Addendum No. 1

Water Main Replacement Project for F St. & 16th St., Sparks, NV

PWP Bid No. WA-2016-181

June 6, 2016

6
D2
36" MAIN - MAIN CONNECTION & DUAL BLOW OFF ASSEMBLY
N.T.S. - F St. & 15th St.

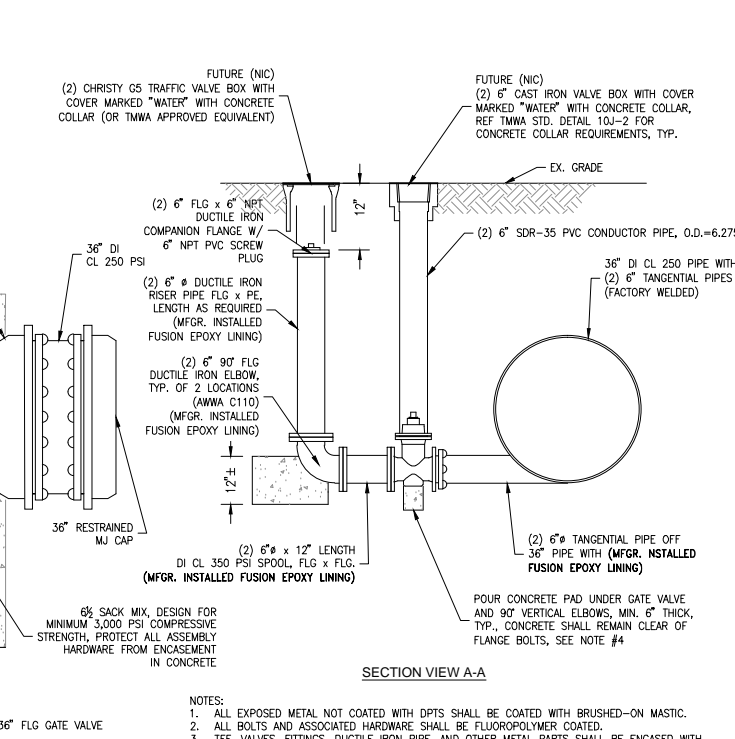
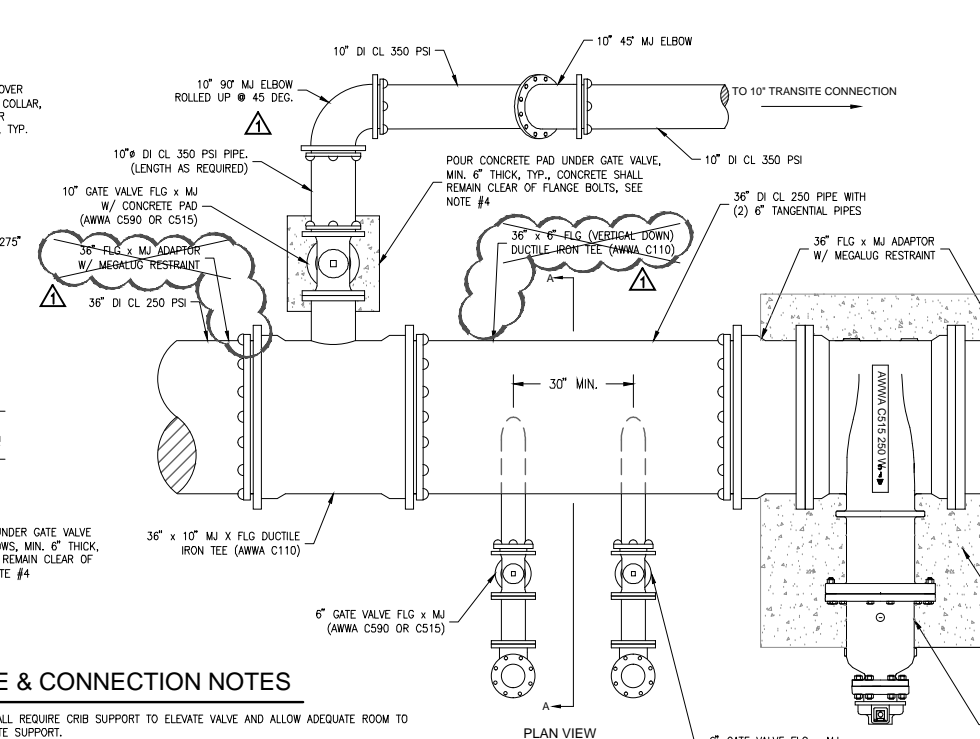
1. Drawing sheet D2 - Details; Detail 6/D2; Deletion of redundant text as indicated by revision cloud and labeled as "delta 1" in the revision table. Replace sheet D2 with the attached revised D2 sheet in its entirety.

REVISION	DESCRIPTION	BY	APP	DATE
1	REVISED DETAIL 6 - ADDENDA 1	RA		6/2/16
